- .1 Cover Page – Addendum No.6 – 1 page;
 - .2 Civil Addendum C2 dated March 28, 2018 – 1 page;
 - .3 Architectural Addendum A4 dated March 28, 2018 – 20 pages including 9 drawings;

Architectural Addendum A4

PROJECT TITLE	East Hants Aquatic Centre
---------------	---------------------------

DRAWING TITLE
MILLWORK DRAWINGS

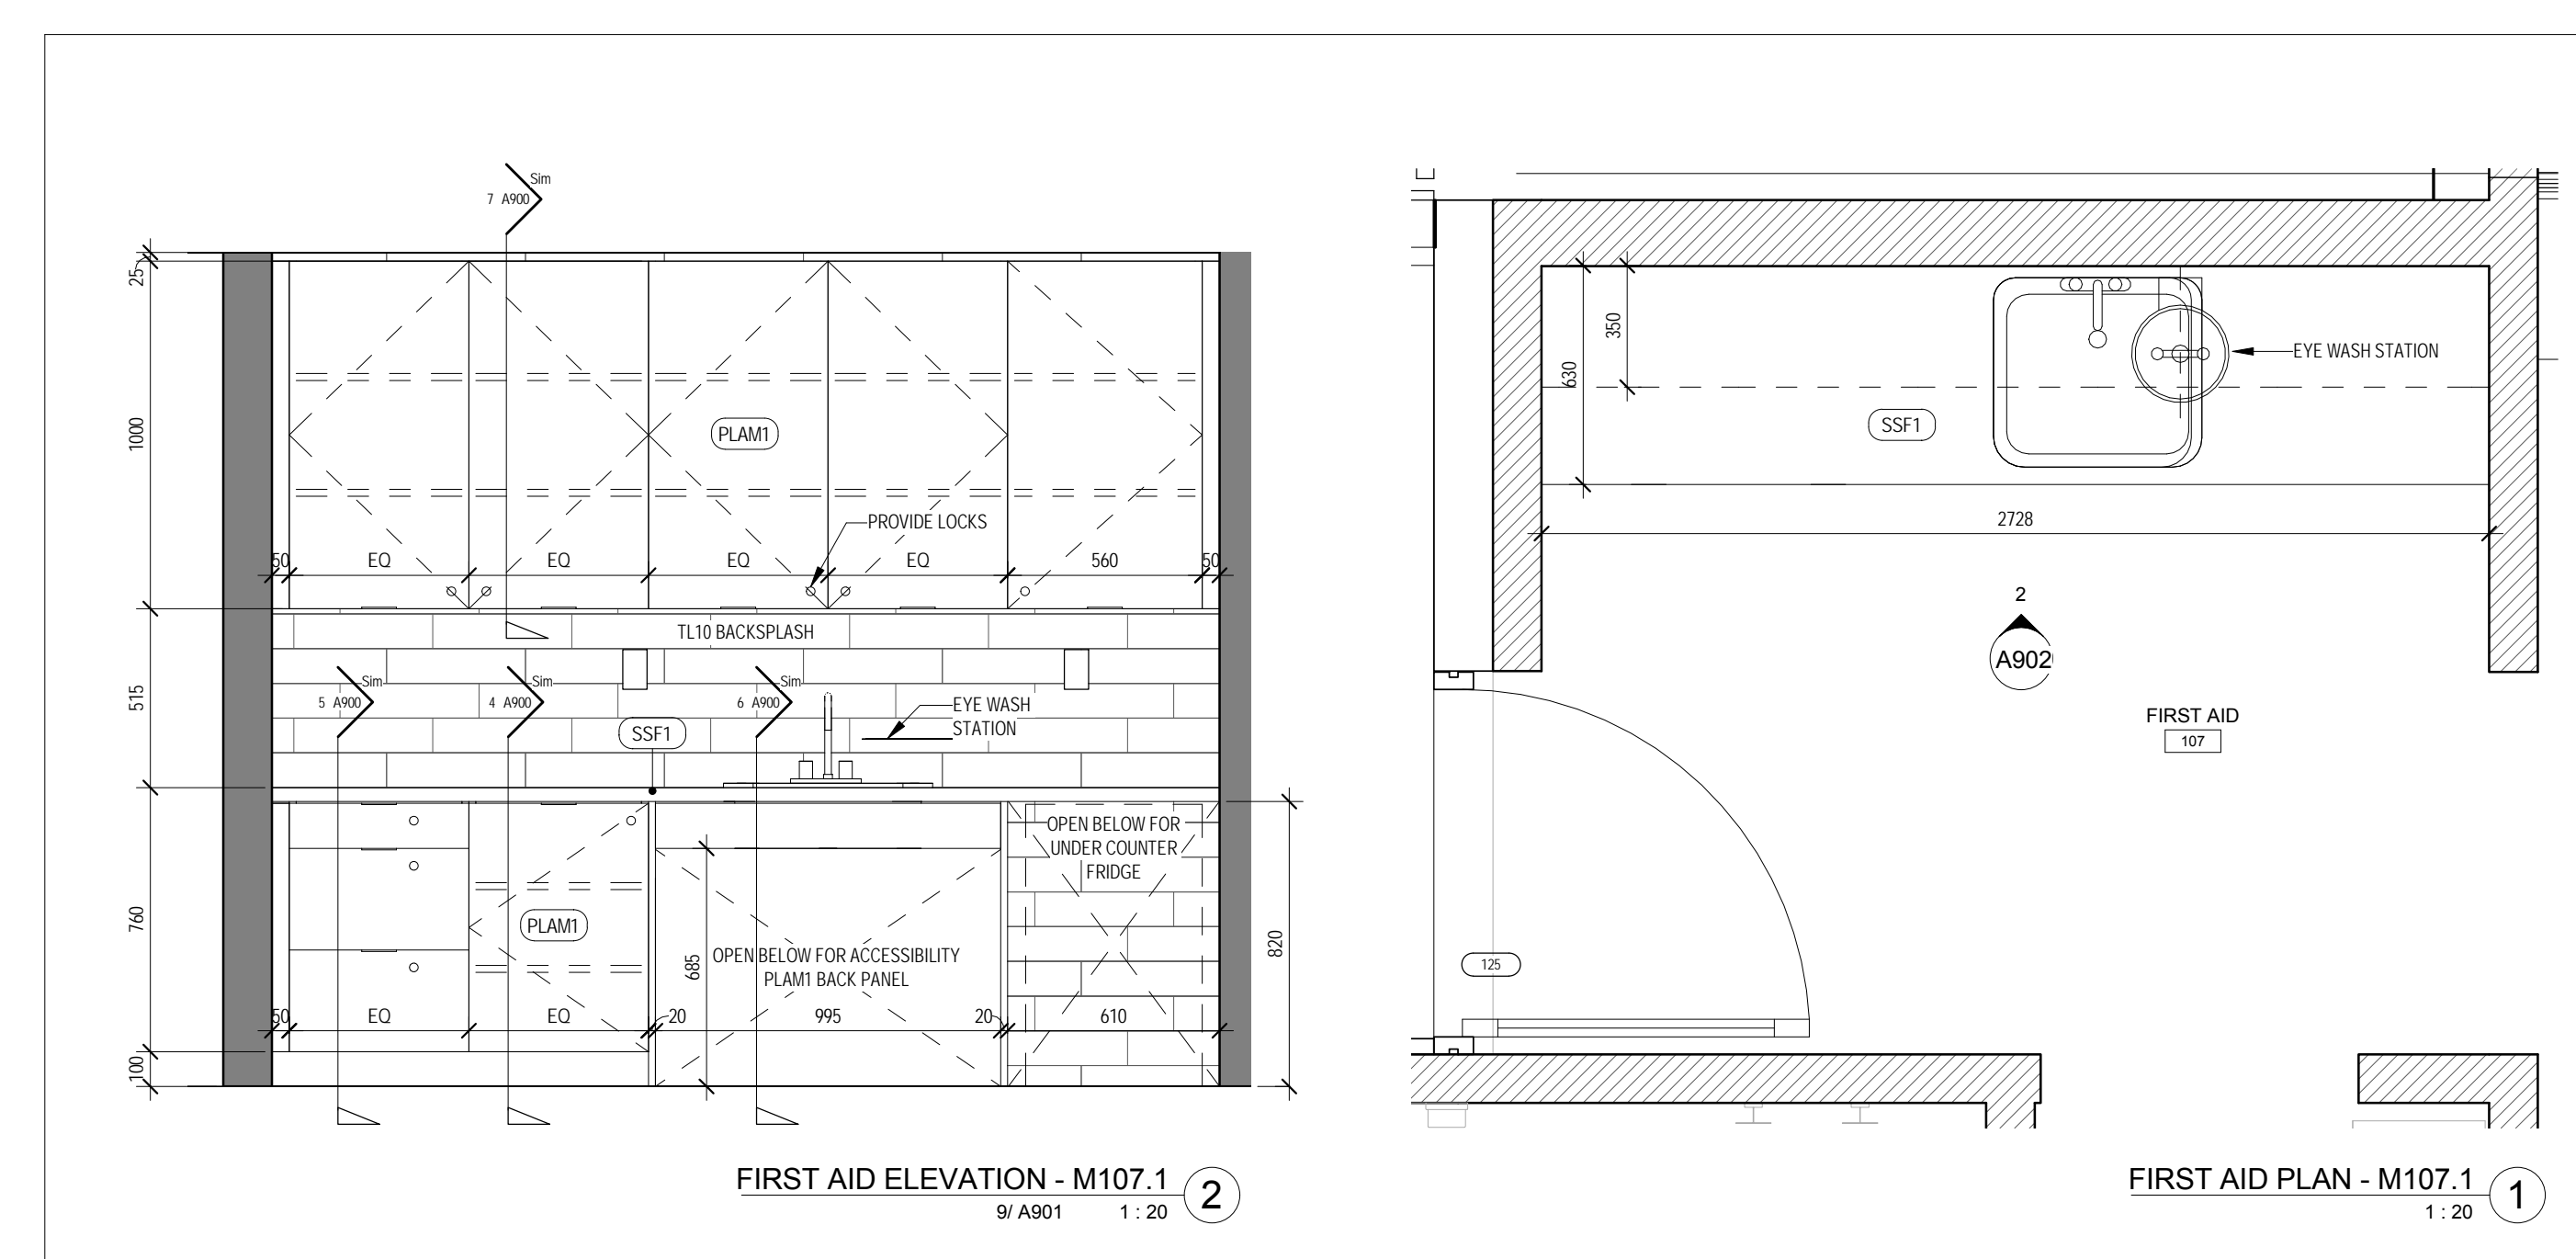
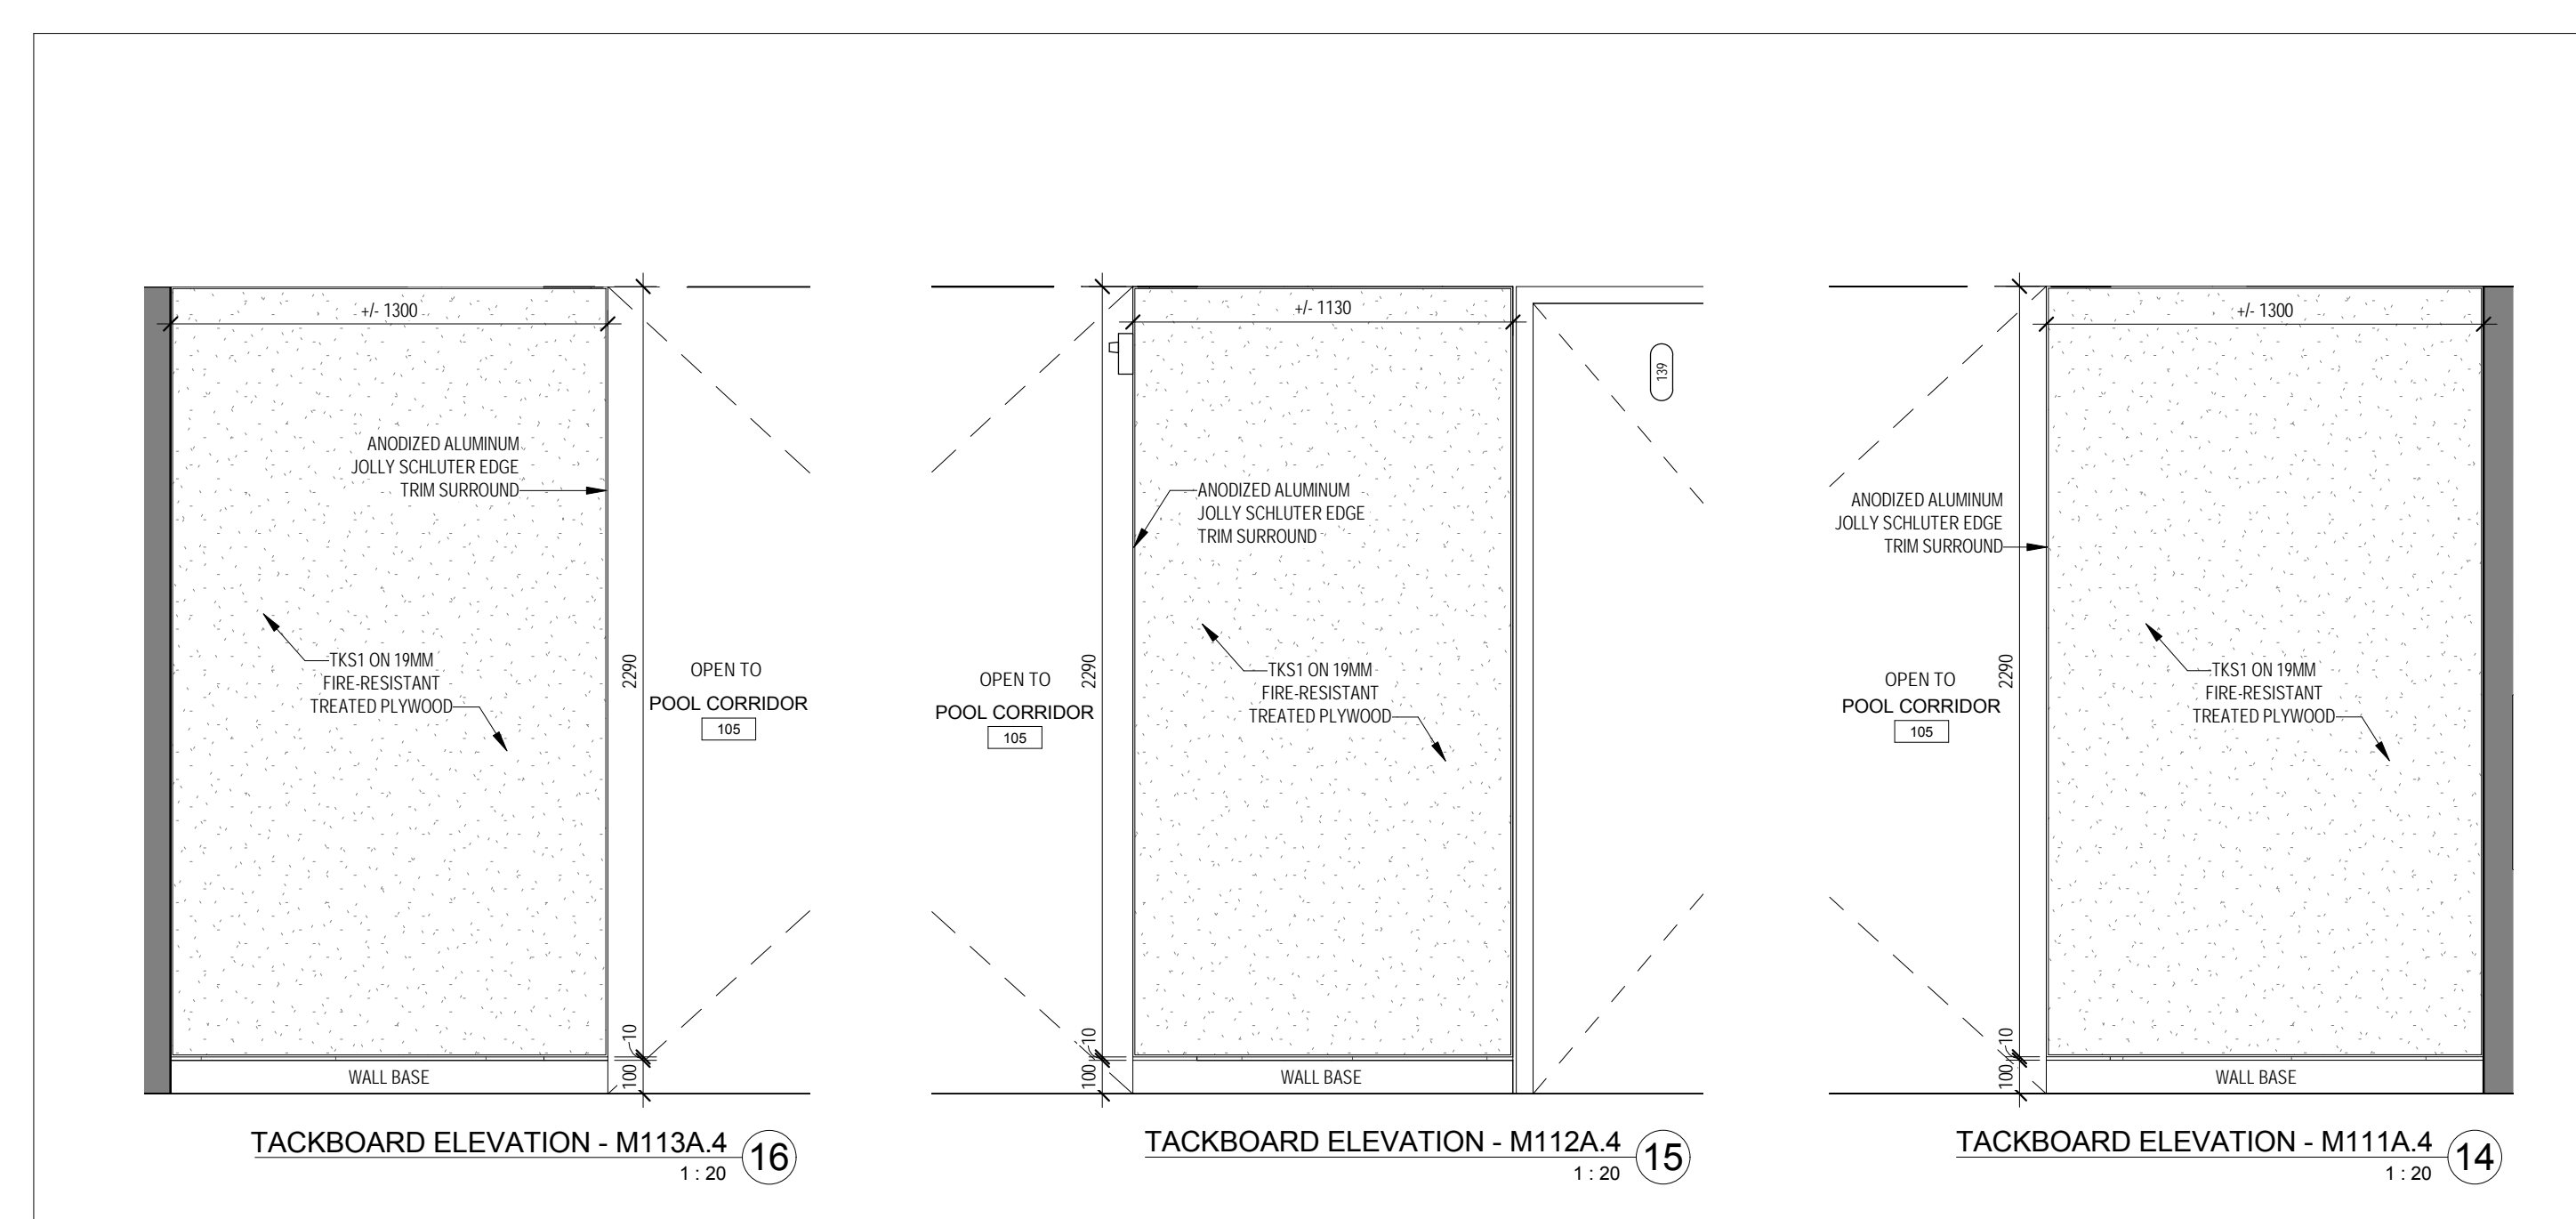
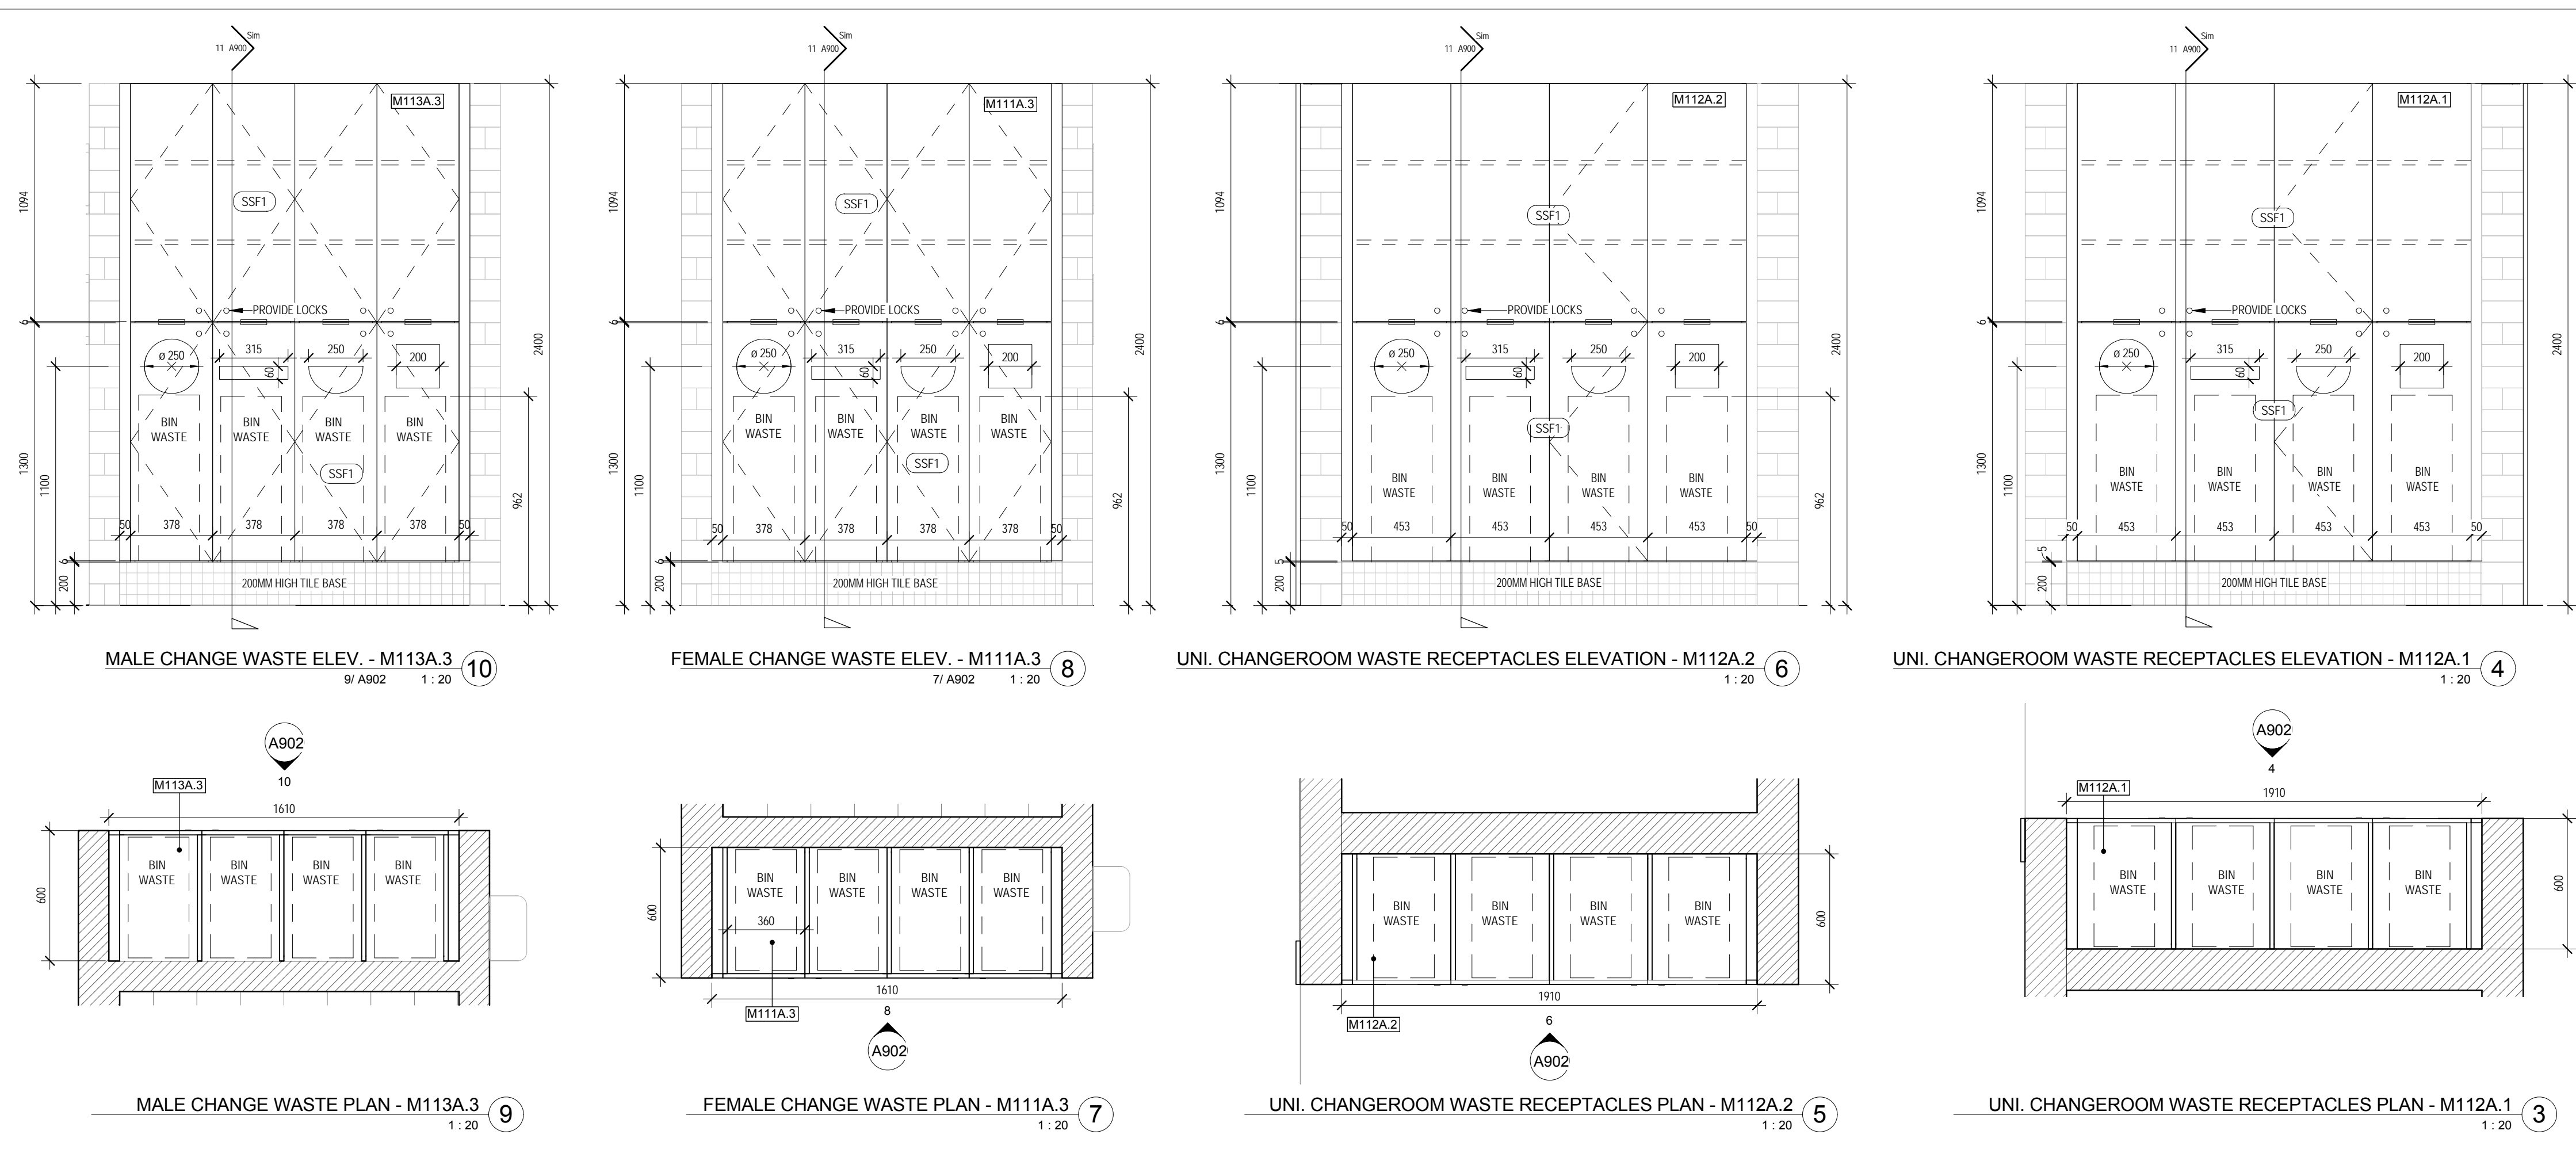
- .1 Drawing A900 “MILLWORK DRAWINGS”, dated 2018-03-28 “Issued for Addendum No.6 to replace and supersede drawing A900 “MILLWORK DRAWINGS”, dated 2018-03-01 “Issued for Tender”. Changes include but are not limited to:
 - .1 Detail 11/A900: REVISED to provide additional information regarding composition of cabinet door.

- .1 Drawing A901 “MILLWORK DRAWINGS”, dated 2018-03-28 “Issued for Addendum No.6 to replace and supersede drawing A901 “MILLWORK DRAWINGS”, dated 2018-03-01 “Issued for Tender”. Changes include but are not limited to:
 - .1 Detail 12/A901: REVISED to accommodate communications box, phone BIX and TV panels.
 - .2 Detail 13/A901: REVISED to accommodate communications box, phone BIX and TV panels.
